ATTACHMENT 1  
PROPOSED TECHNICAL SPECIFICATION CHANGES

## 6.0 ADMINISTRATIVE CONTROLS

### 6.1 Organization, Safety and Operation Review

# OFF-SITE ORGANIZATION FOR FACILITY MANAGEMENT AND TECHNICAL SUPPORT

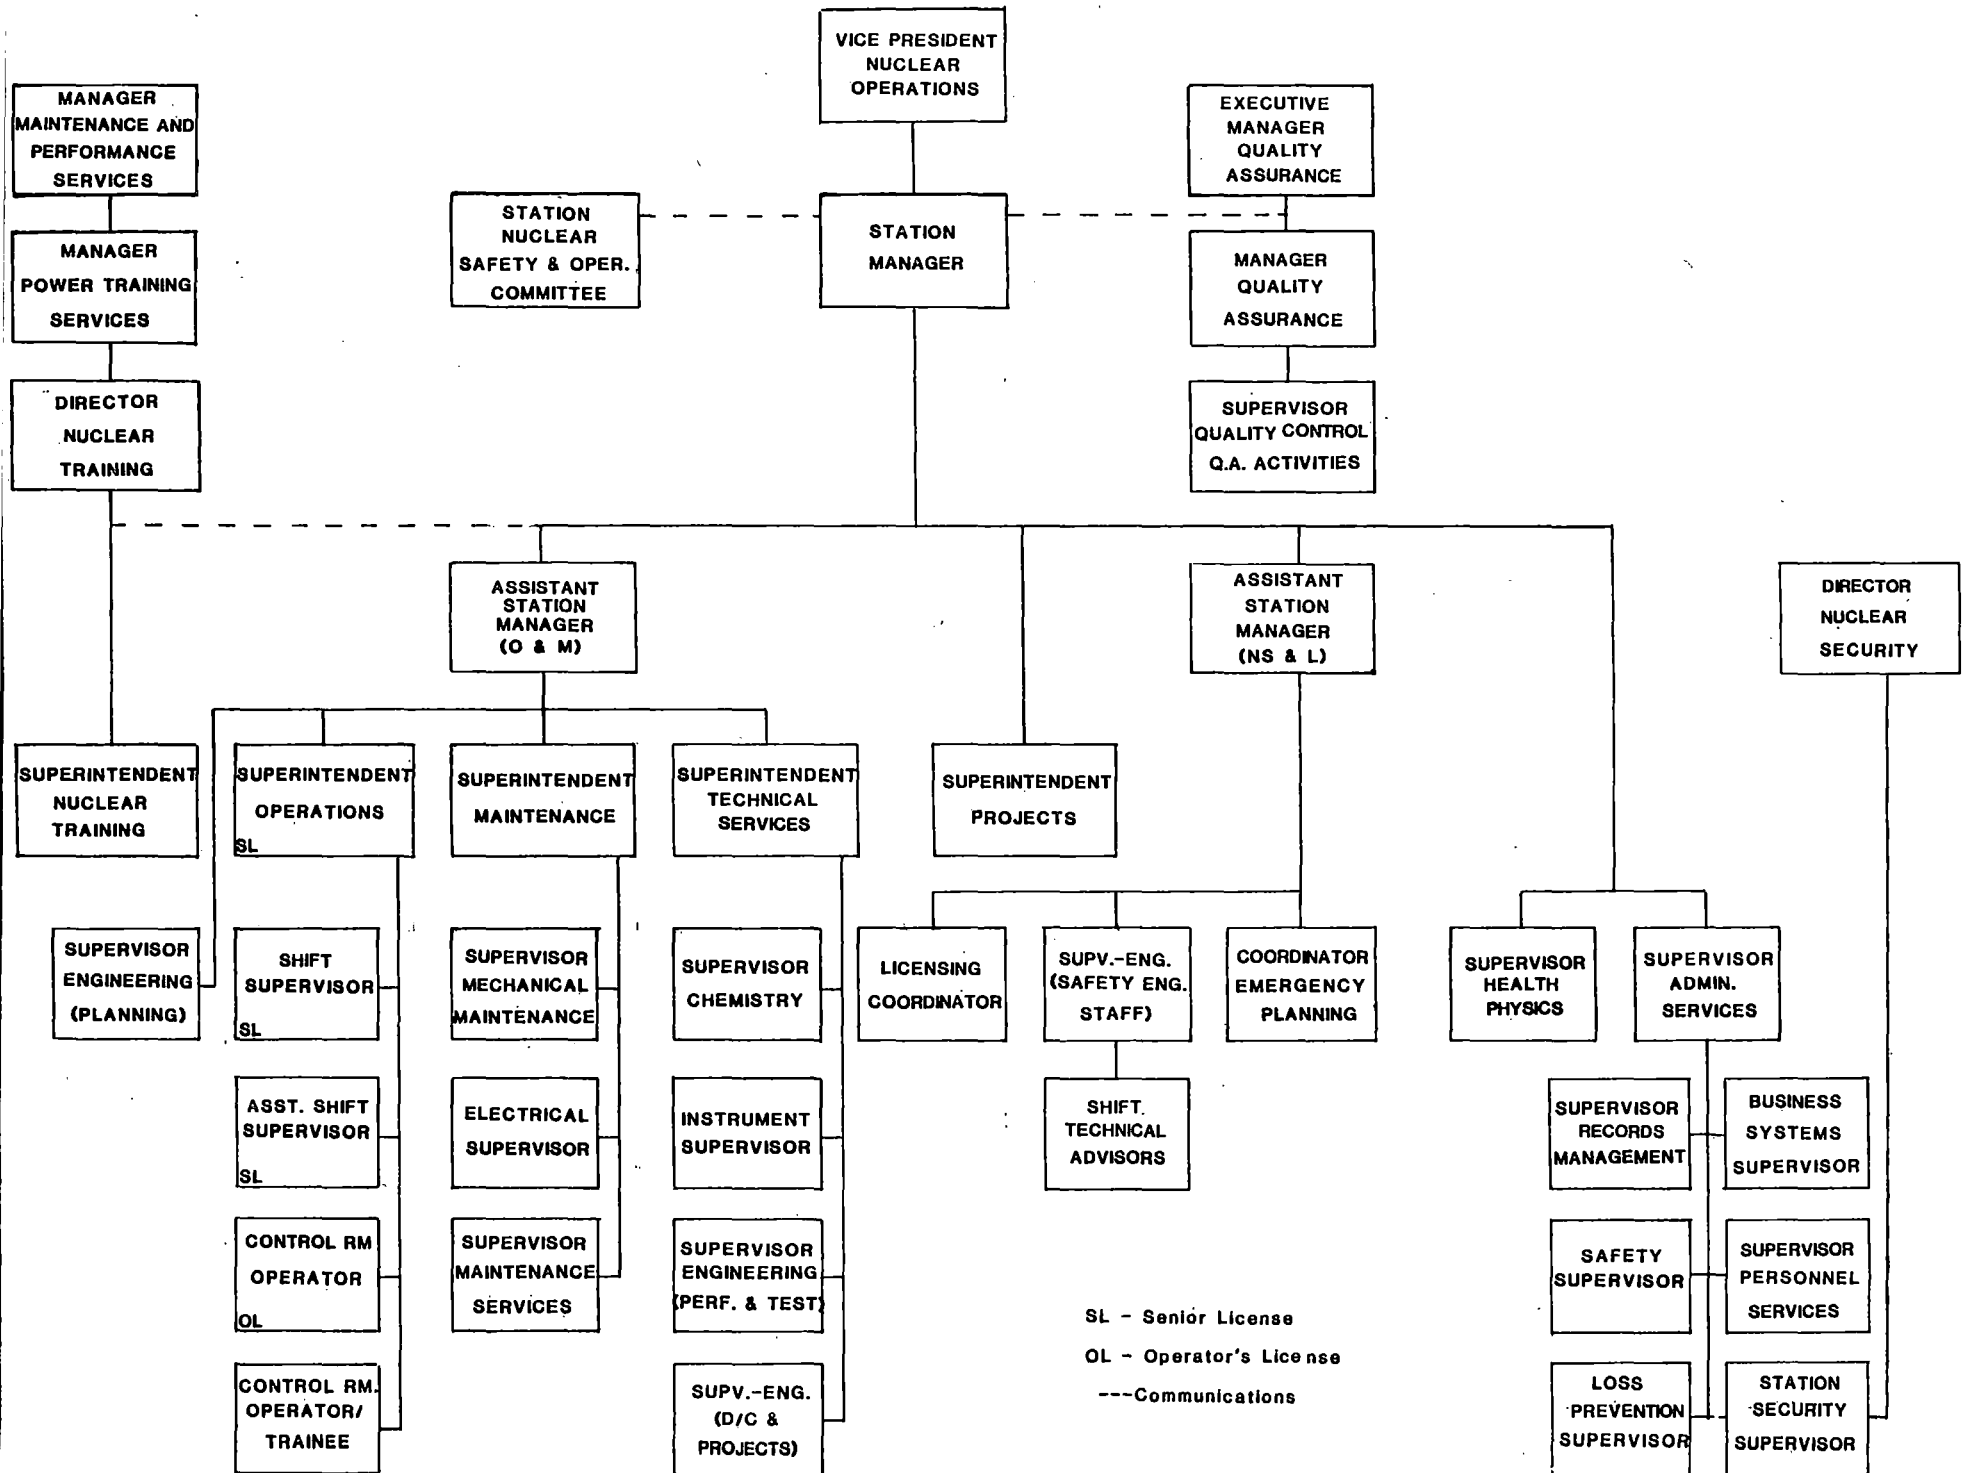
A reorganization within the Nuclear Operations Department eliminated the position of Manager, Nuclear Operations and Maintenance. The Technical Analysis and Control group was disbanded and its functions assumed within the Safety Evaluation and Control Staff, NOD, and within the Engineering and Construction Division. The Manager, Nuclear Technical Services was retitled Manager, Nuclear Operations Support and assumed the responsibilities of the Manager, Nuclear Operations and Maintenance. The new Fuel Operations group also reports to him.

Several other title and reporting changes took place: The title of Executive Vice President was changed to Executive Vice President and Chief Operating Officer. The Director, Administrative Services now reports directly to the Vice President-Nuclear Operations.

A reorganization within the Security Department also took place. Although the Station Security Supervisor will continue to have communications with the Supervisor, Administrative Services at the station, he now reports to the Corporate Director, Nuclear Security.

The authority of the new Manager, Nuclear Programs and Licensing is identified and he is designated to receive records of Safety Evaluation and Control (SEC) activities and Quality Assurance (QA) audits. Figures 6.1-1 and 6.1-2, showing both corporate and station organizations, are revised accordingly. The Figures also incorporate the organizational changes previously submitted and are further discussed below.

A reorganization within the Quality Assurance Department resulted in the Manager, Quality Assurance at the station reporting directly to the Executive Manager, Quality Assurance. The position of Director-Emergency Planning was created within the Nuclear Operations Department. The changes were to enhance the quality assurance and emergency preparedness programs of the company.
